B 3.7 PLANT SYSTEMS

ADDITIONAL INFORMATION COVER SHEET

3/4.7 PLANT SYSTEMS

FIGURE 3.7.17-1 (page 1 of 1)

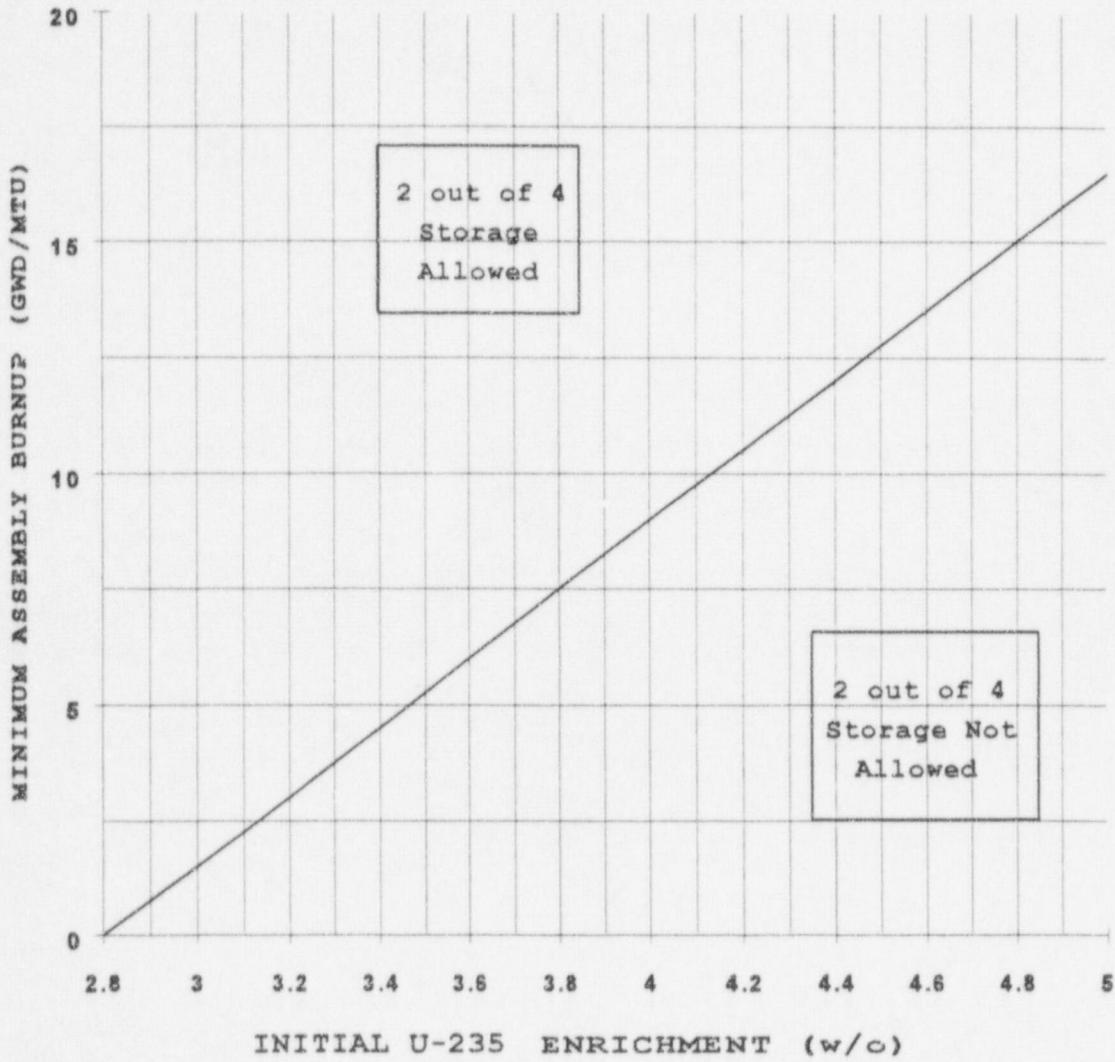
Comment: Issue #1 - The Region 1 and Region 2 designations are not used in the LCO but the high density storage racks are defined as the Applicable basis for this LCO. Figure 3.7.17-1 refers to Region 2 which is inconsistent. **Issue #2** - STS 3.7.16 should be added to the ITS. (See the above Comment 3.7.17.1-2 of this LCO.)

FLOG RESPONSE: (Issue #1)The Title for Figure 3.7.17-1 will be revised to read "Fuel Assembly Burnup Limits in High Density Racks."
